The Tauranga Airport understands the Port is seeking resource consent for its proposed Stella Passage development through the Fast-Track consenting process. Associated with the Stella Passage Development is the inclusion of additional ship to shore container handling cranes as shown on drawing 270-118 Rev A and 324-239 Rev 0.

NAVIGABLE AIRSPACE DETERMINATION: Ship to Shore Cranes, Sulphur Point Wharf, Tauranga

DETERMINATION OF HAZARD IN NAVIGABLE AIRSPACE

**CRANE HEIGHT RESTRICTIONS
 SULPHUR POINT**

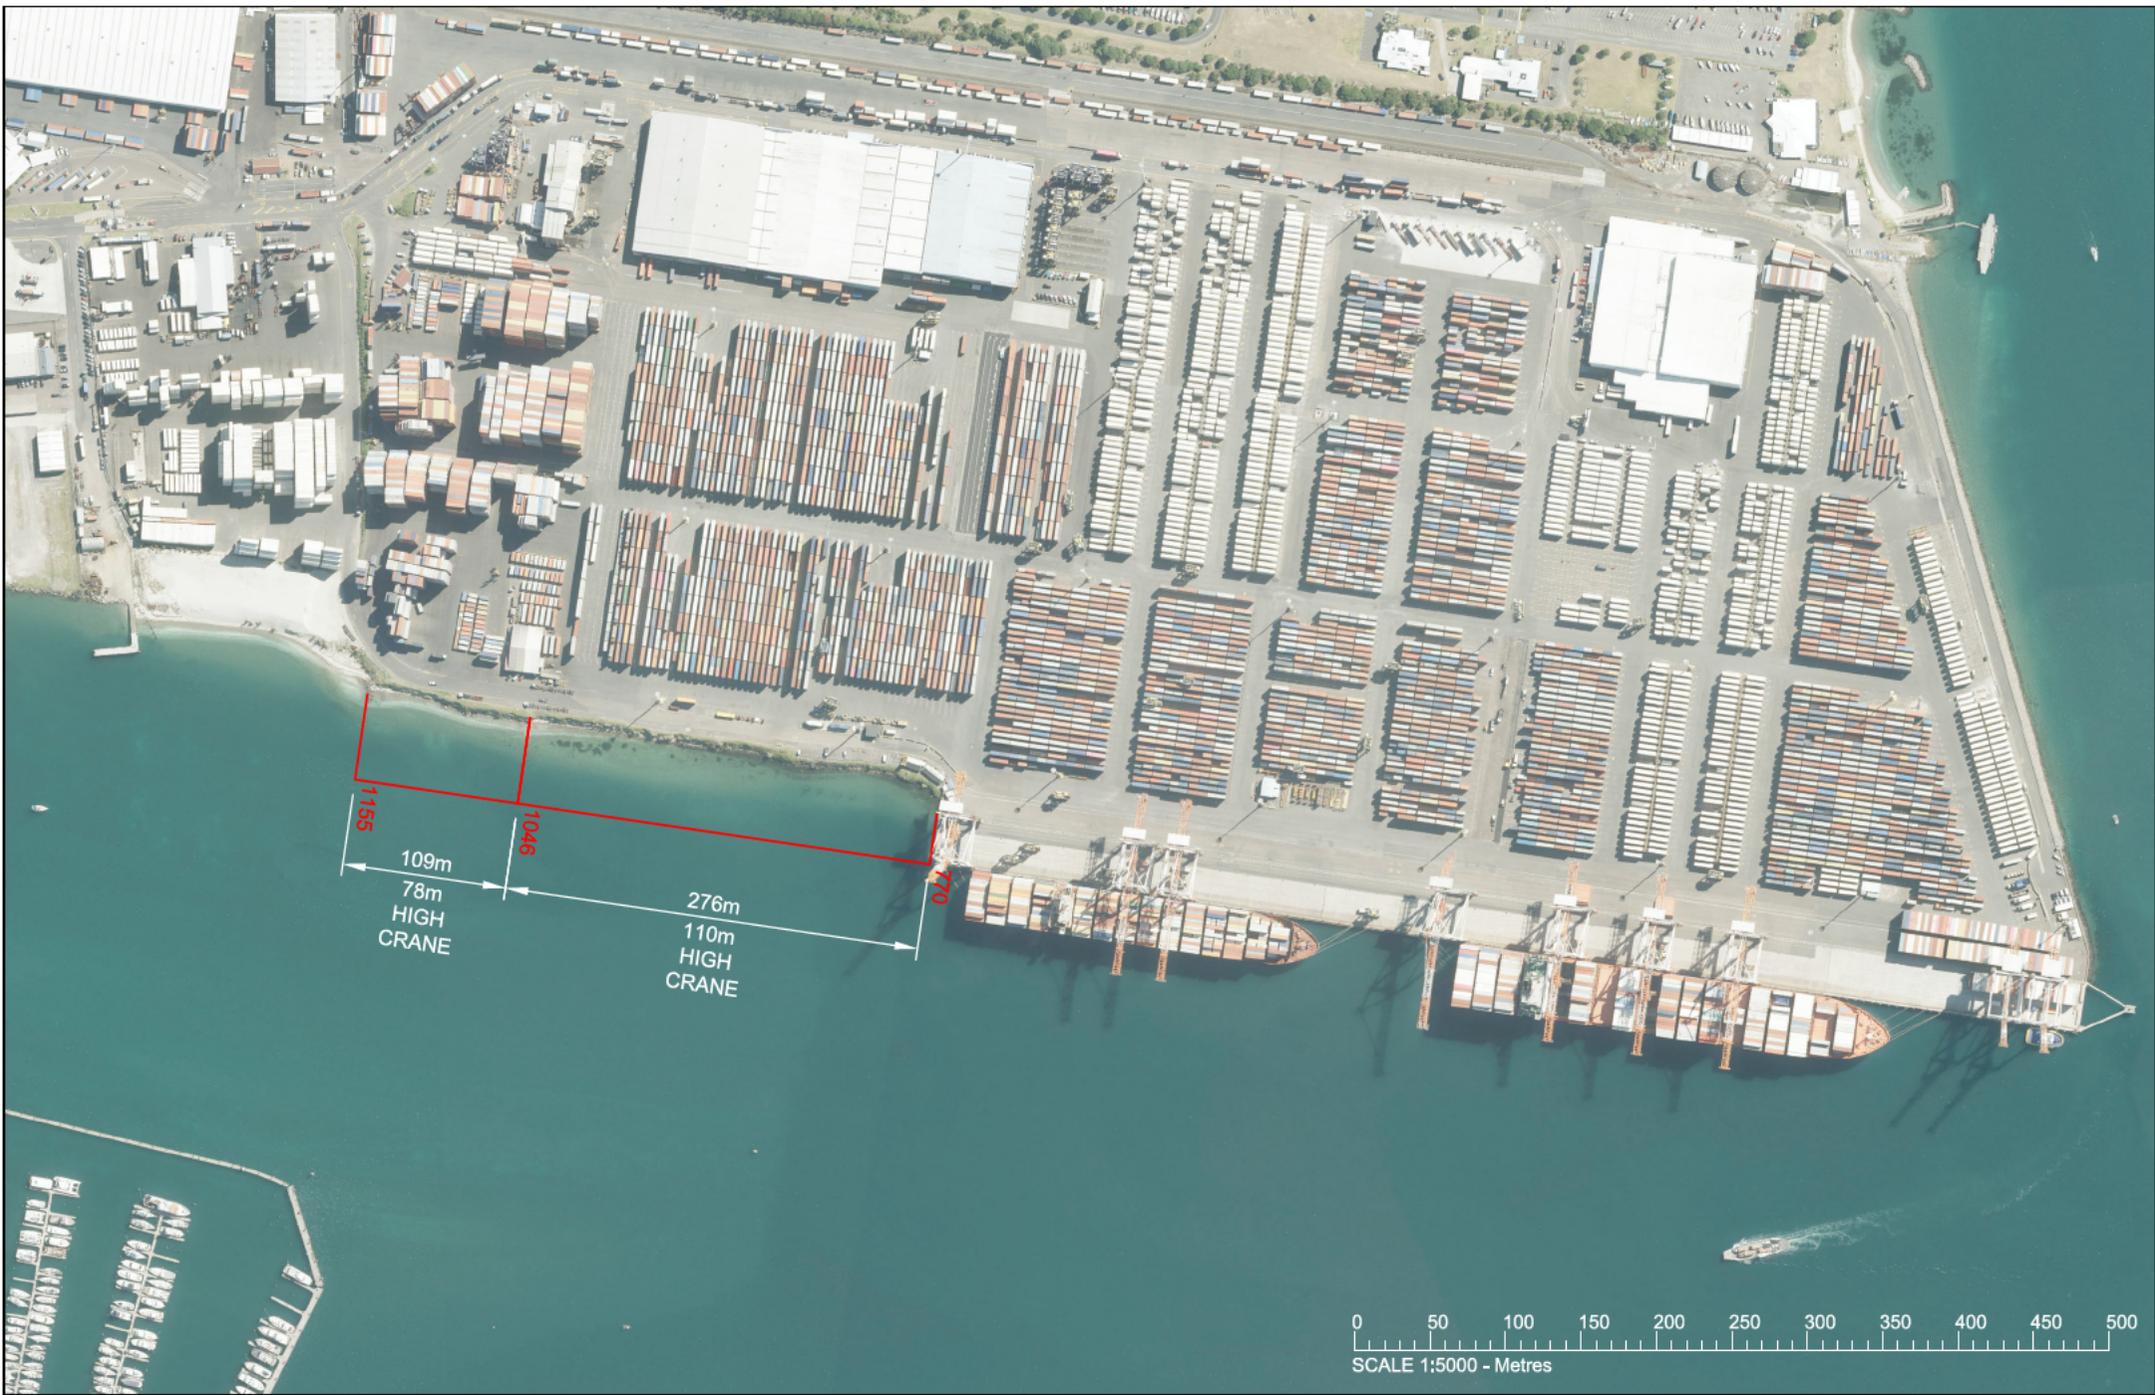
The Tauranga Airport acknowledges the proposed cranes will exceed the permitted height limits of both the Bay of Plenty Regional Coastal Environment Plan (Rule PZ 4) and the Tauranga City Plan (rule 18A.12.3). Under both these rules resource consent is required, and the assessment matters relate directly to the safe operation of the Tauranga Airport.

As per my email of 10 October 2024 the Tauranga Airport is in support of the proposed extension with the provision that Port of Tauranga complies with the below condition 1 of the attached CAA determination, Tauranga Airport will look after the remaining conditions.

1. The cranes operating within the proposed area must be continuously lit at the highest point of the crane and at the end of the boom with an appropriate obstacle light in accordance with (IAW) Civil Aviation Rule Part 77, Appendix B; and

Plan OLS (based on 300m strip width) with those shown in Figure 04-2 (based on 150m strip width).

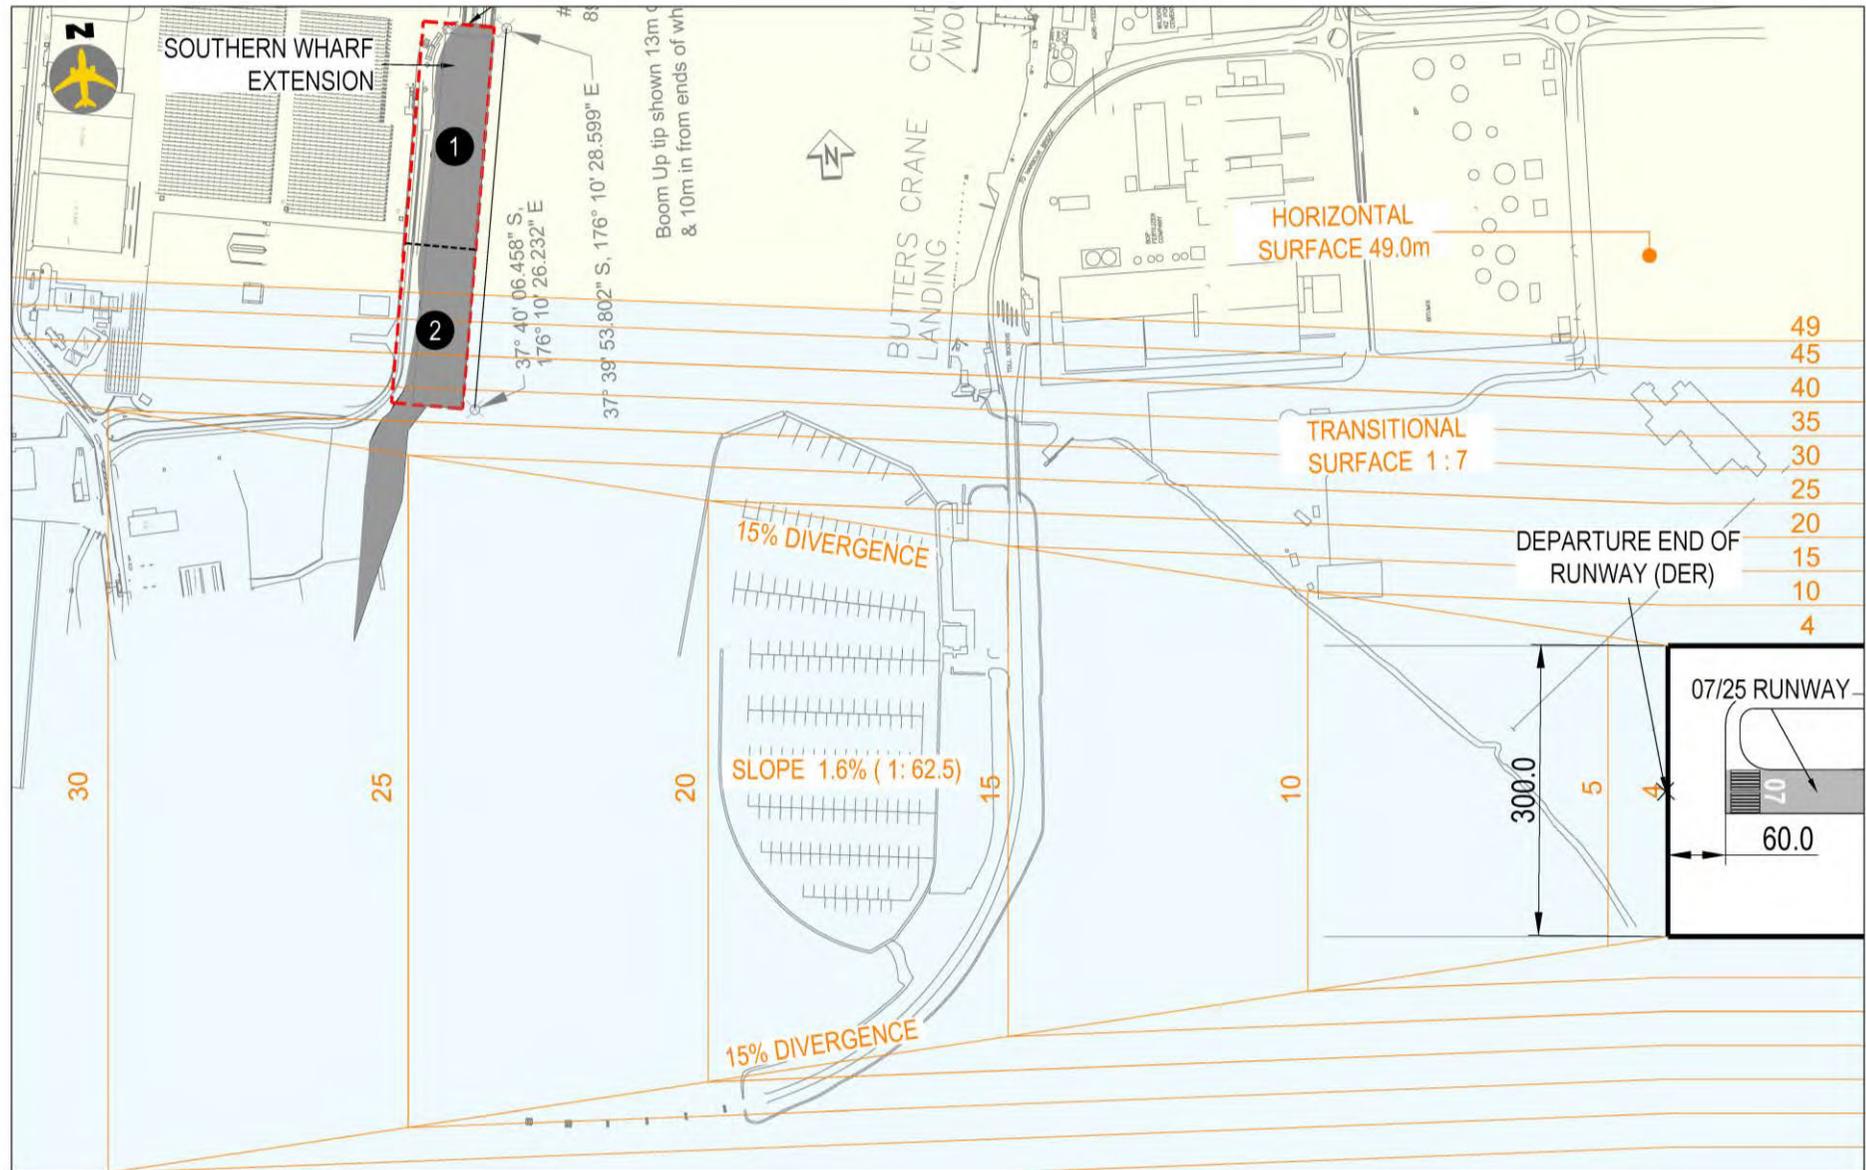
For the 220m wharf extension, denoted as Area 1 in Figure 04-1, there would not be an infringement of the Transitional Side Surface.

For the possible longer term additional extension to the full 385m extent, denoted as Area 2 in Figure 04-1, there could be potential infringements of the Transitional Side Surface in the southernmost 120m of the wharf extension, occurring as low as the 32m contour of the Surface, depending on what obstacles might be installed or present there, which could include:

Accordingly, this Study recommends that the OLS risk issue relating to the Transitional Side Surface does not require a specific mitigation other than the adoption of the narrower OLS based on the declared 150m runway strip width.

Figure 04-2 OLS Based on Declared 150m Runway Strip

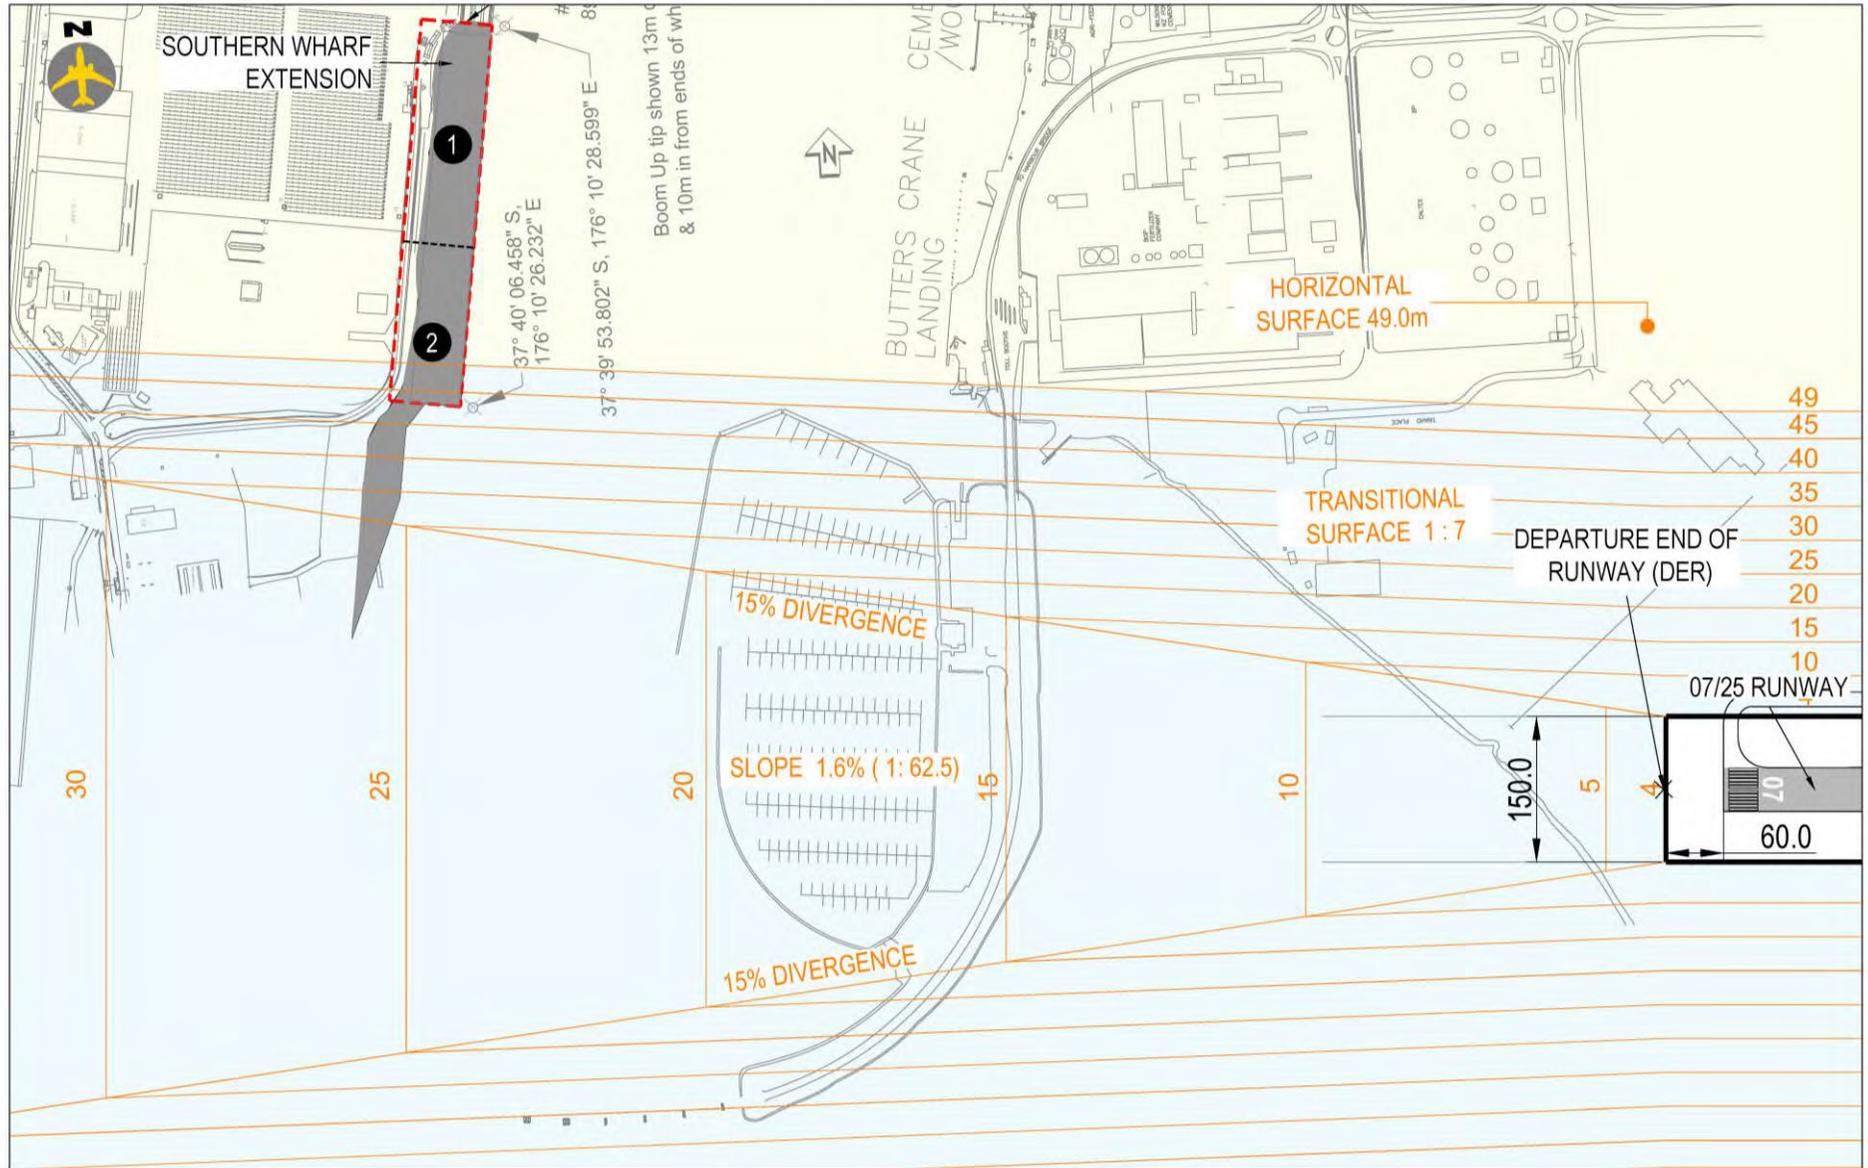
If the OLS were based on declared 150m runway strip width the extent of the Side Transition surface breach would be reduced. The potential infringements of the Transitional Side Surface would then be in the southernmost 45m of the longer term additional extension to the full 385m extent wharf extension, occurring as low as the 43m contour of the Surface. The reduced Transitional Side Surface breach is shown in Figure 04-2.

Figure 05-1 Departure Splay with 6.5% Climb Gradient

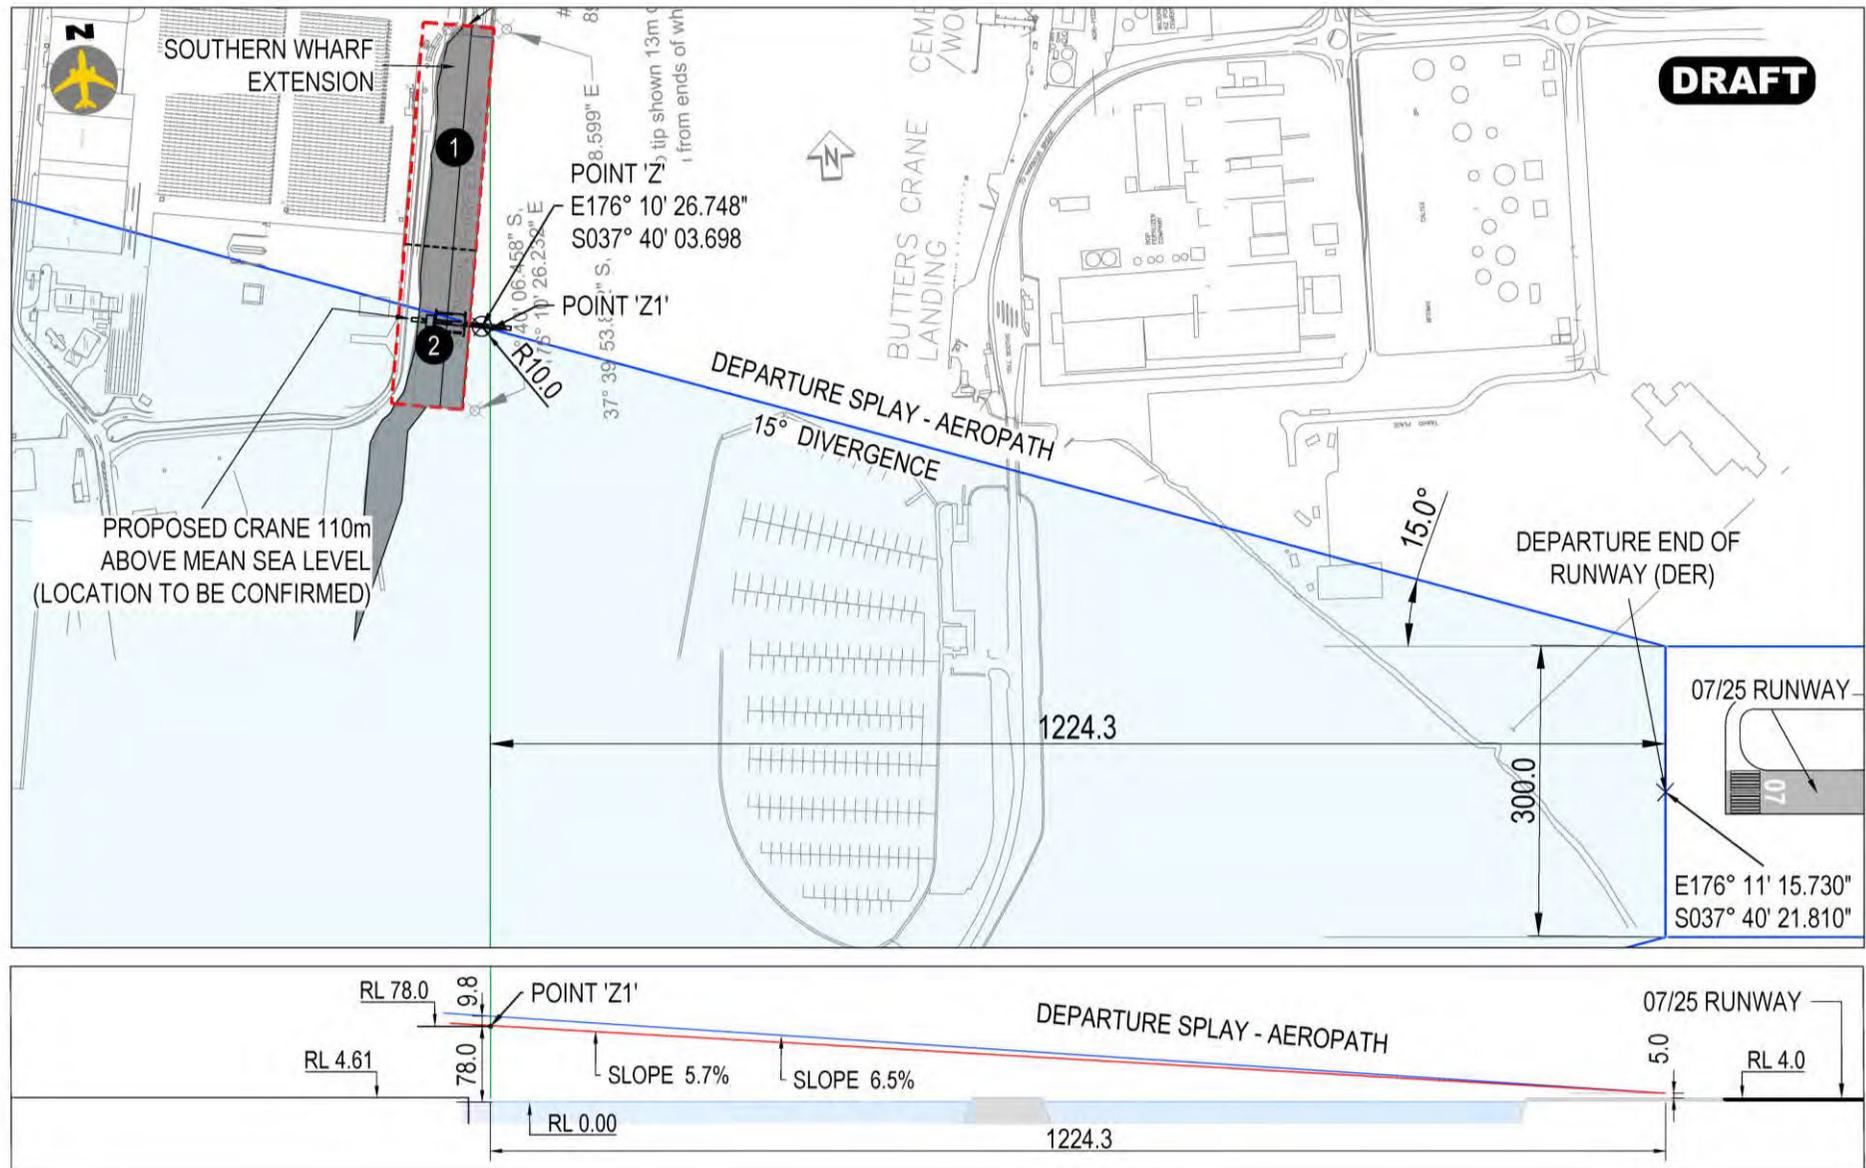
The critical aspect is the requirement that any obstacle must not infringe the Splay surface, potentially restricting installations in the southern-most half of the longer term additional extension to the full 385m extent, denoted as Area 2 in Figure 05-1 an extent of approximately 90m at the southern end.

obstacles installed on the proposed Wharf extension of 78m (depending on obstacle location). This is illustrated in Figure 05-1.

It is understood that Aeropath and Air New Zealand will be prepared to work together to achieve the modified procedures to achieve this mitigation.
